CITY OF TONTITOWN PLANNING OFFICE

Meeting: **January 23rd, 2024**
Project: **Industrial Circle LSD**
Planner: Zak Johnston, P.E.

INDUSTRIAL CIRCLE PRELIMINARY LSD PC AGENDA ITEM 2

895 E Henri De Tonti BLVD
Parcel # 830-37799-000

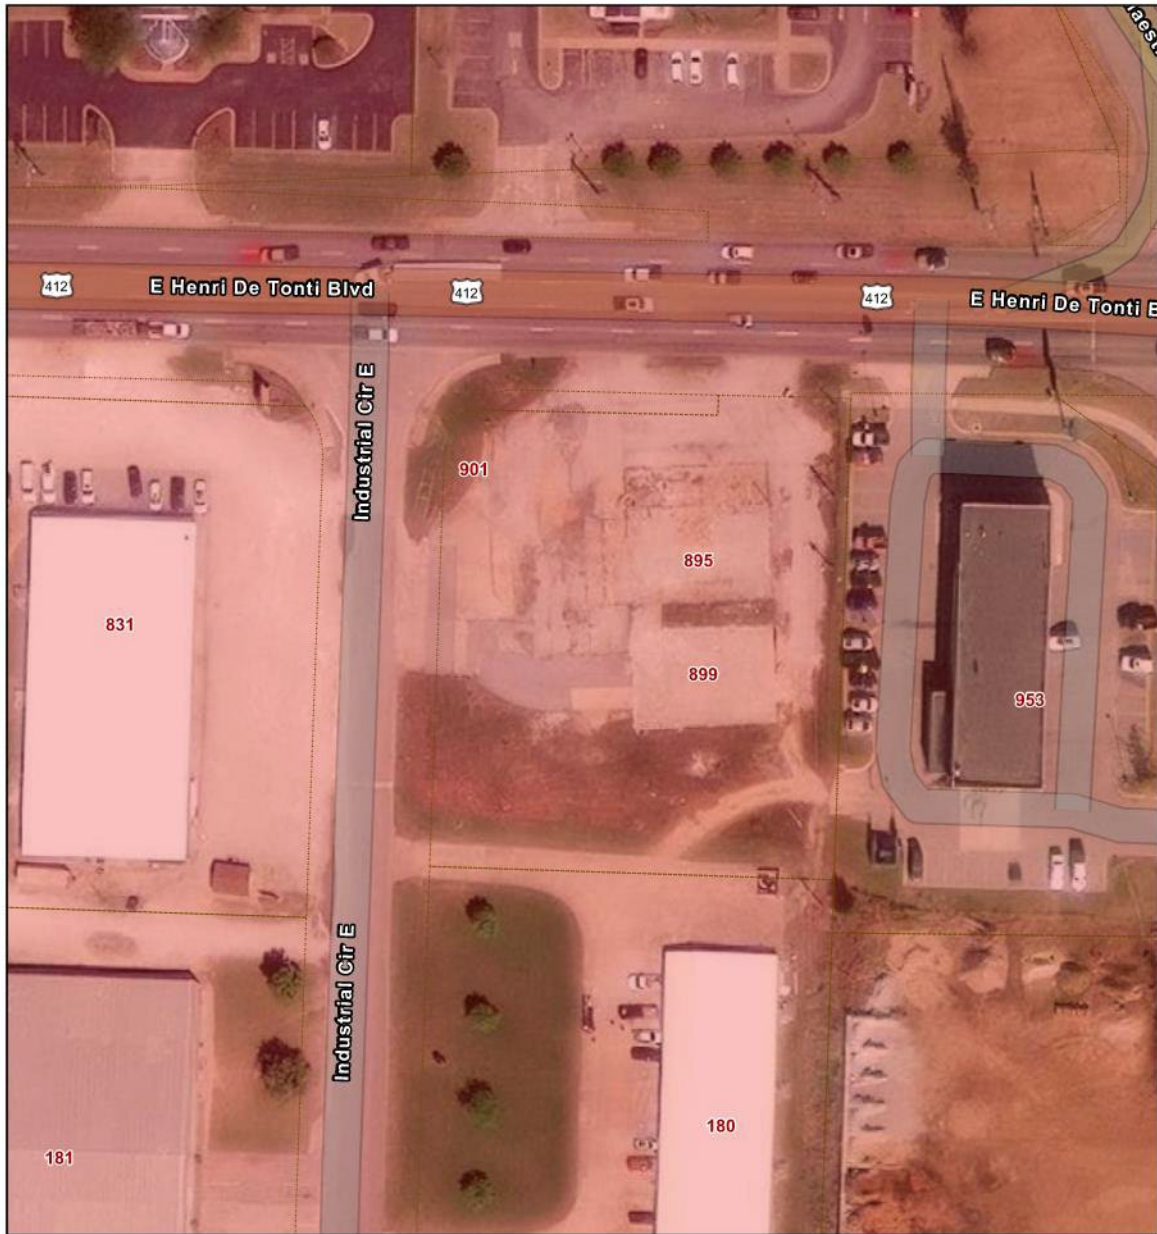
1. Additional topo is needed along Industrial CIR to check drainage with new curb and gutter installation. An additional curb inlet may be required. Please coordinate with City Engineer before construction plan approval.
